FOR BUILDING REGS

Bungley Lane, Kirton - Phase 2
 Plot 1

Ground & First Floor Plans

Roof Plan
 Elevations

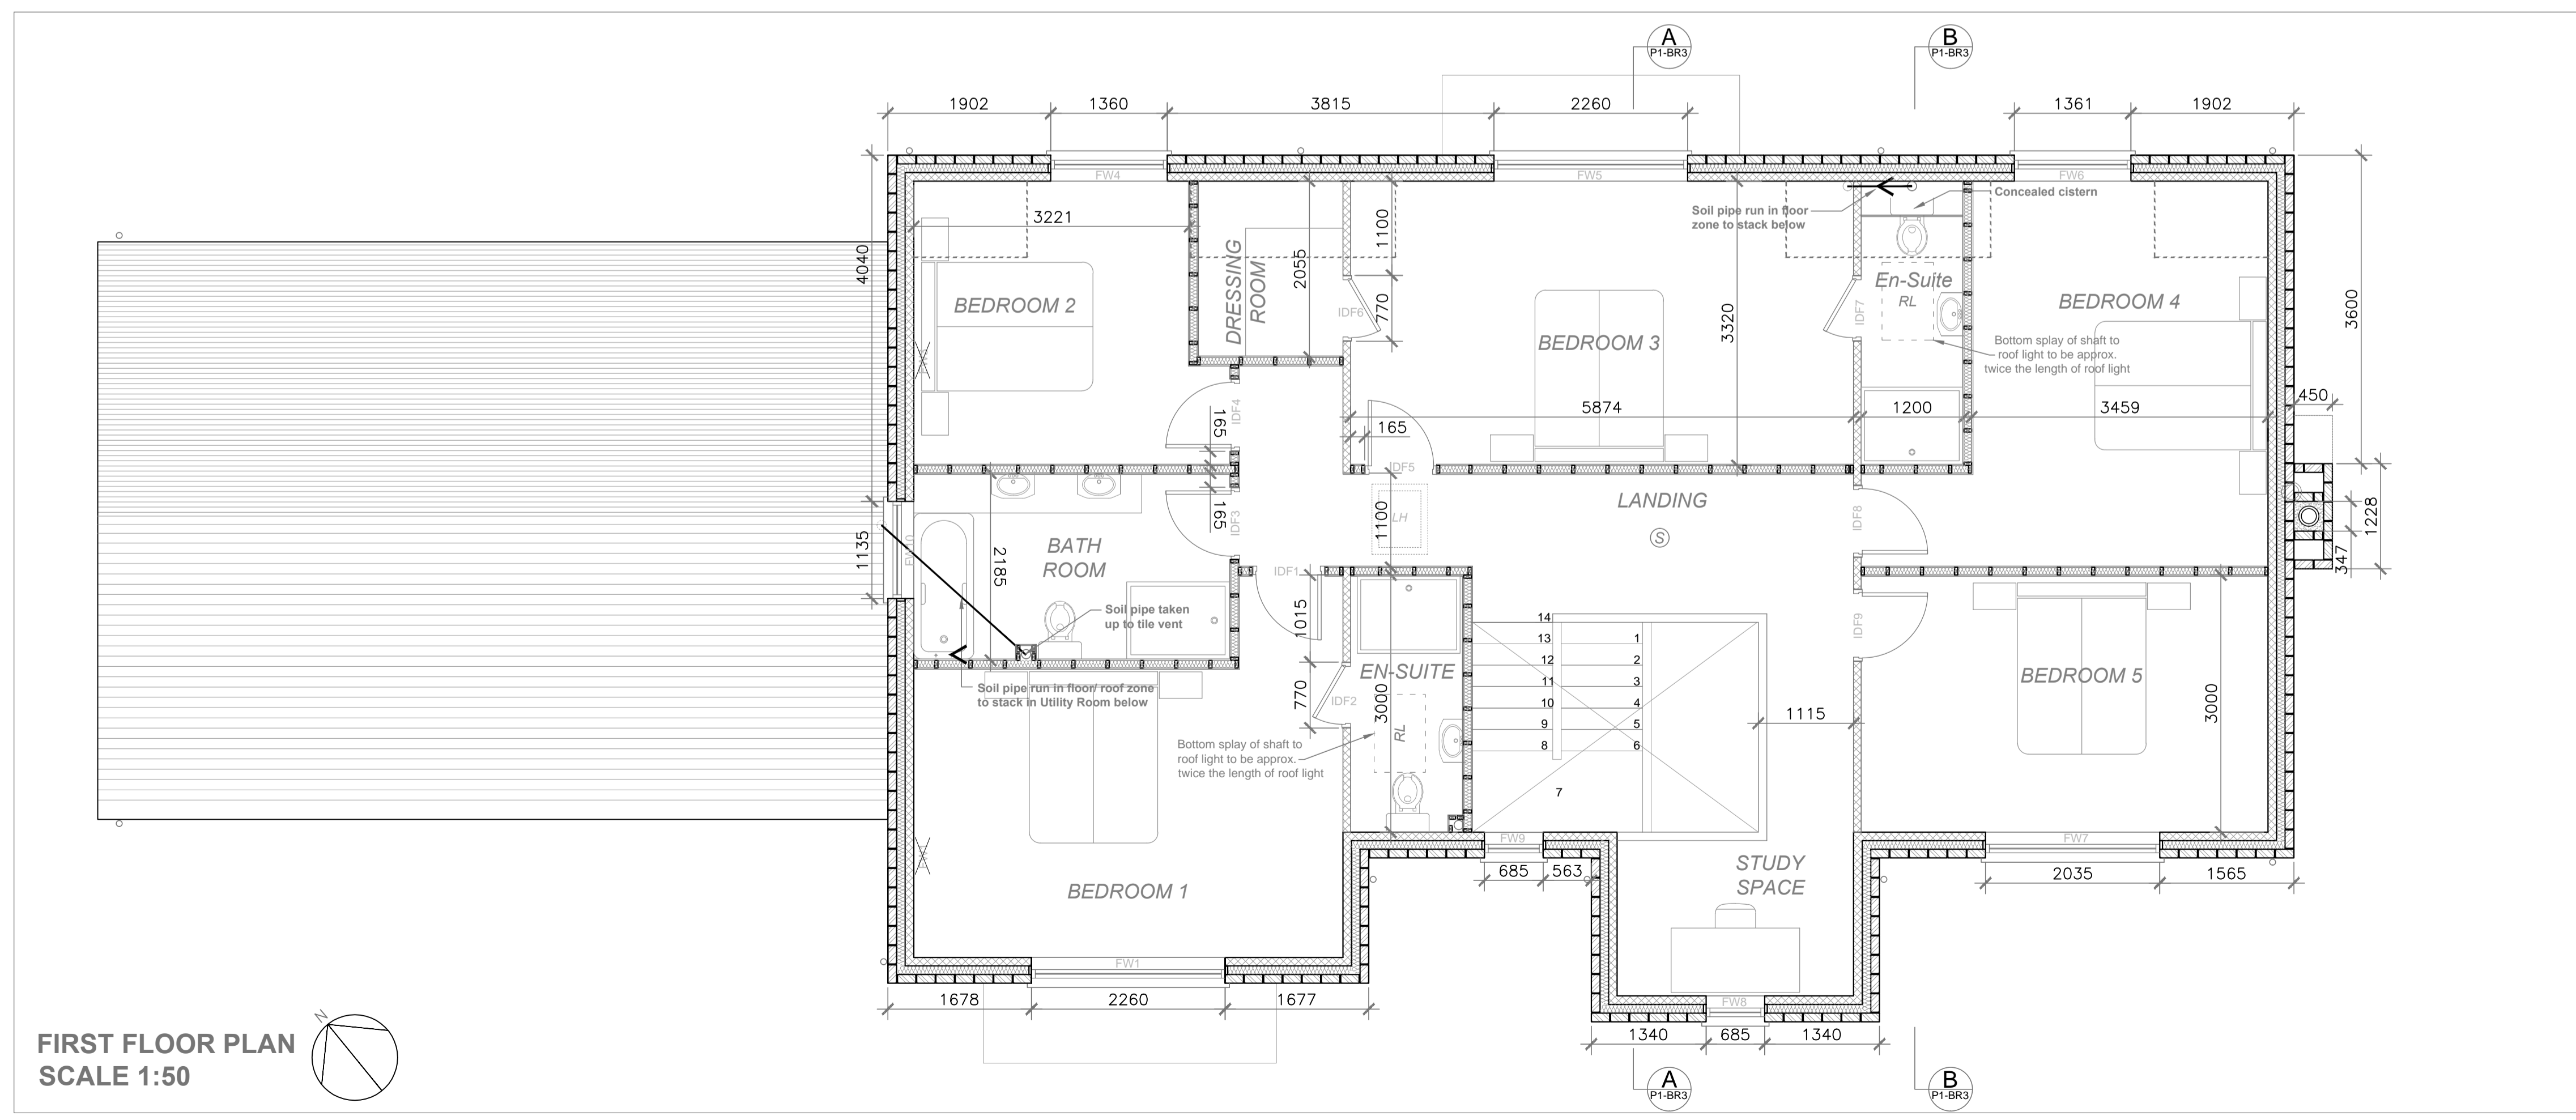
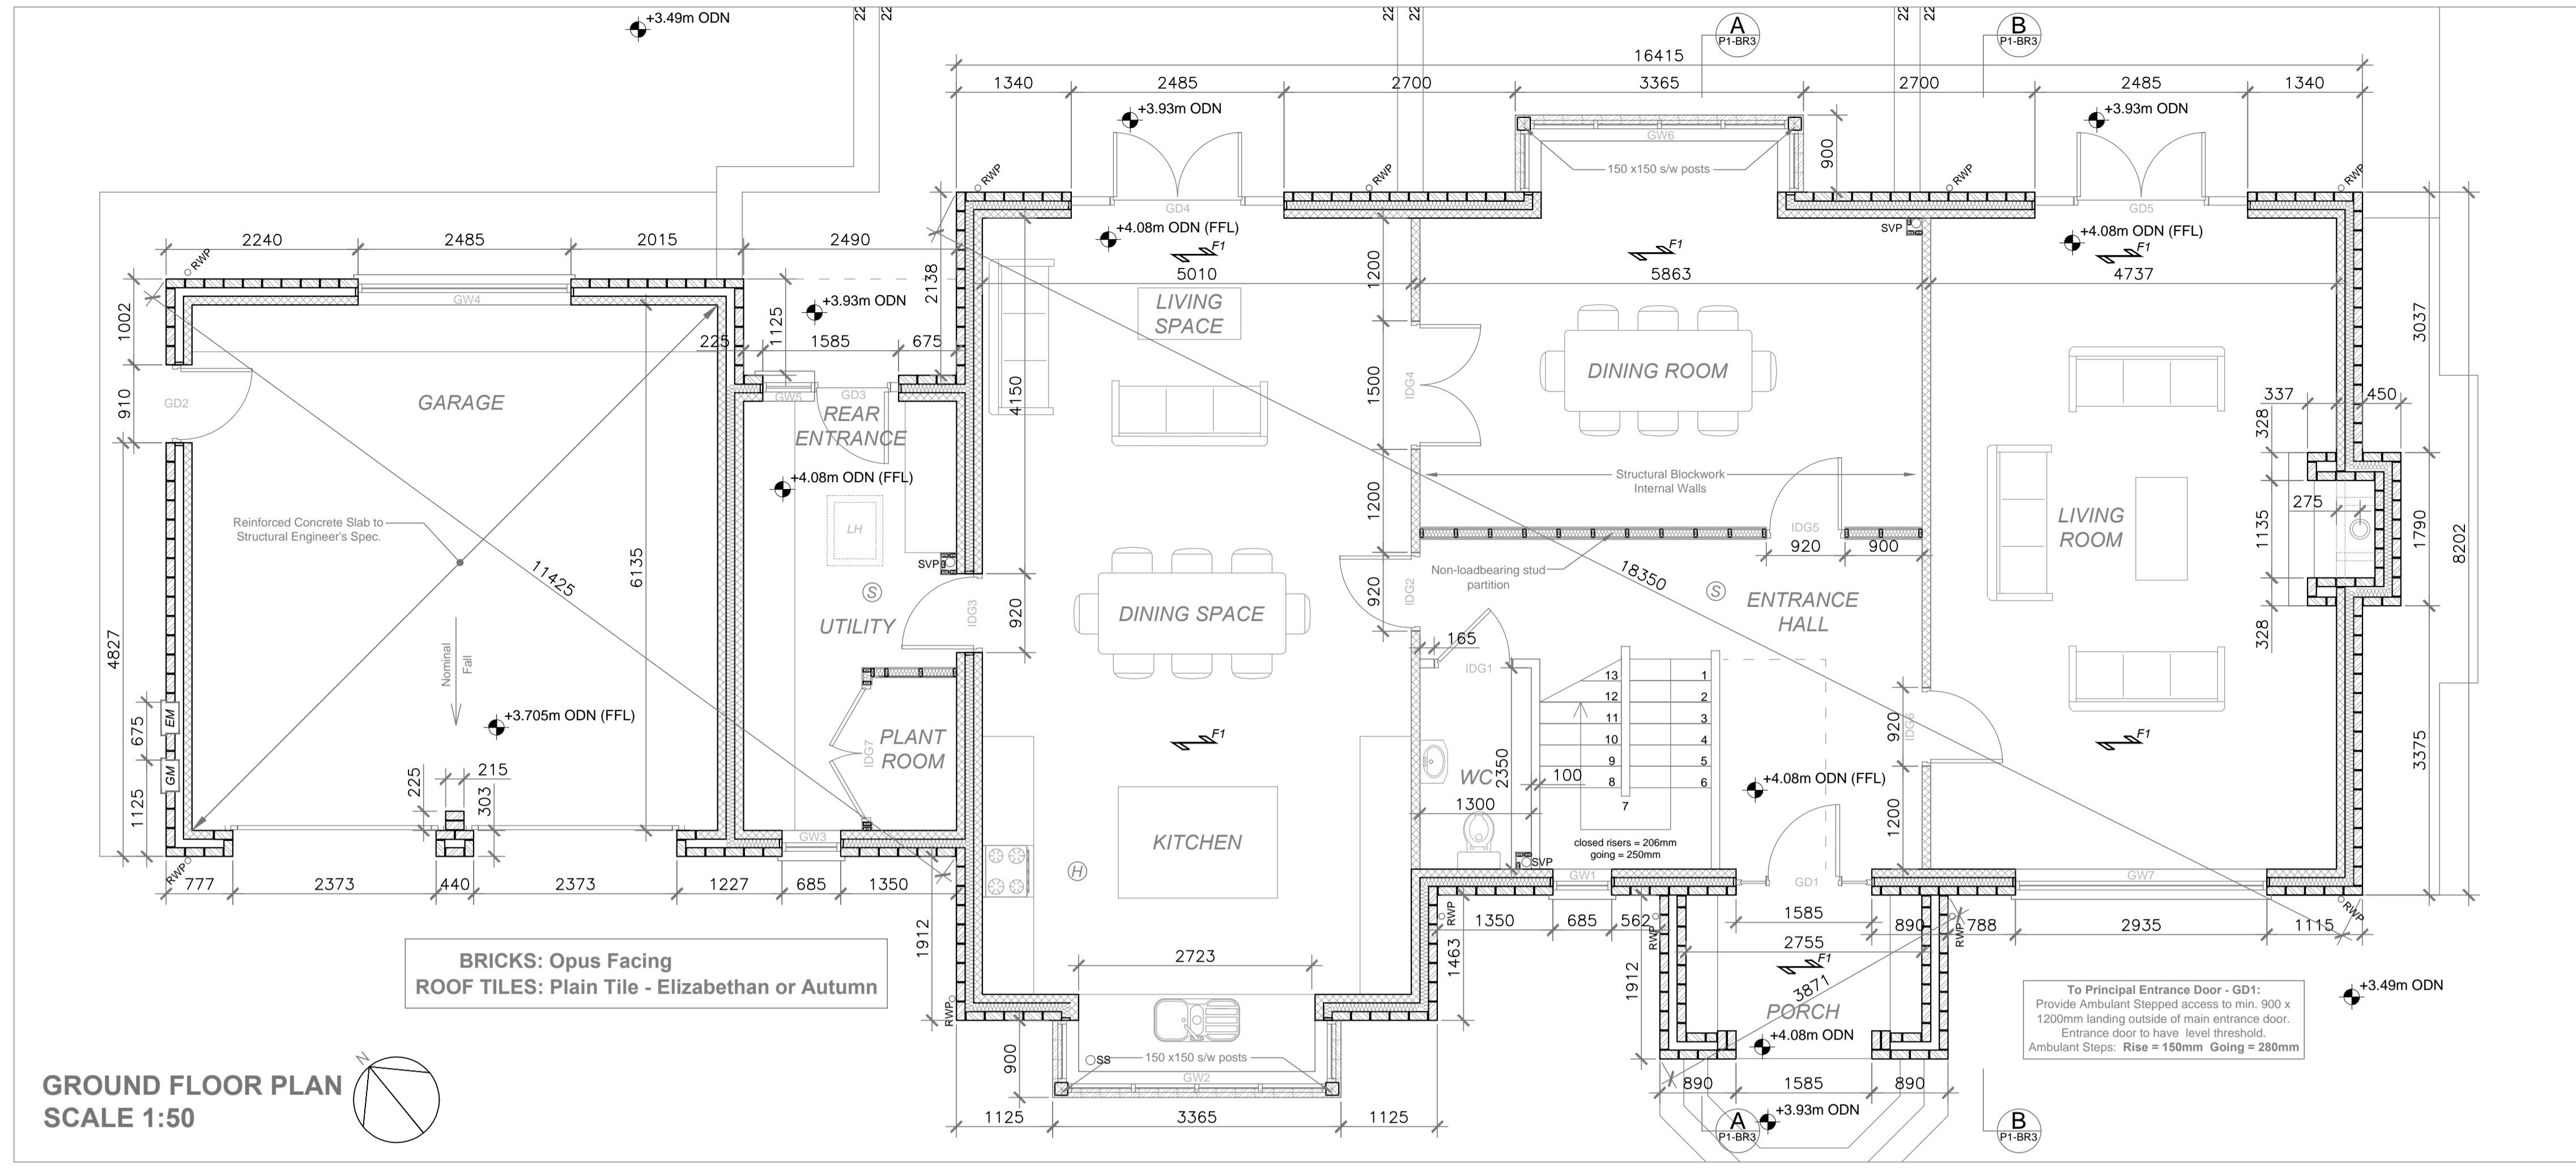
A Internal French Doors (IDC6) into Living Room 18.08.20 GF GF replaced with Single Door. Two Small Windows (FW1 & FW3) on the North West Elevation Removed. GD4 & GD5 structural opening narrowed.

B Ground Plan Revised to Show Stud Wall 13.10.20 GF GF Partition between Entrance Hall & Dining Room

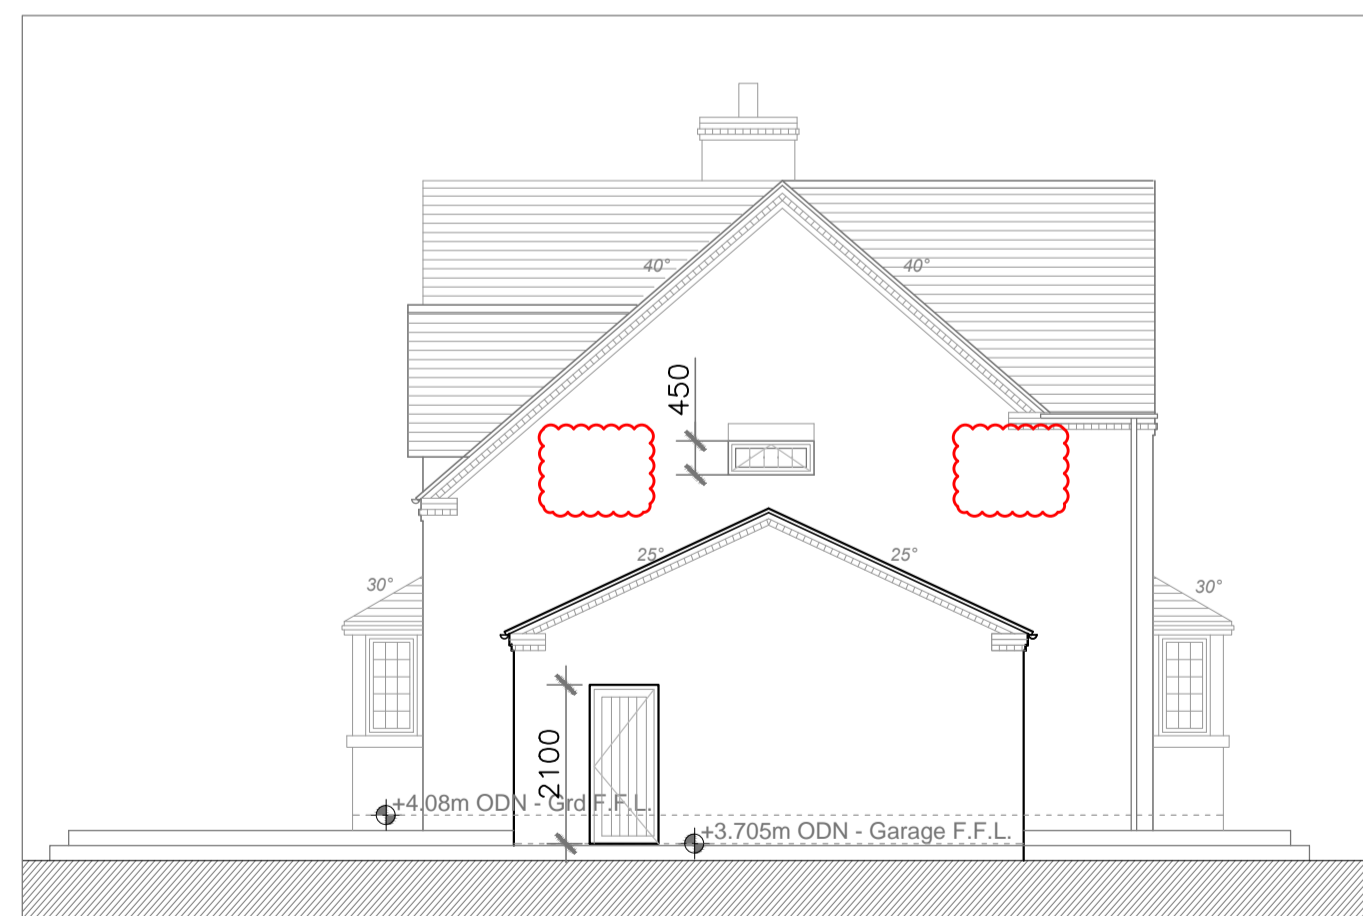
A Two Small Windows on the North West Elevation Removed. Heads to certain windows squared instead of played. 18.08.20 GF GF
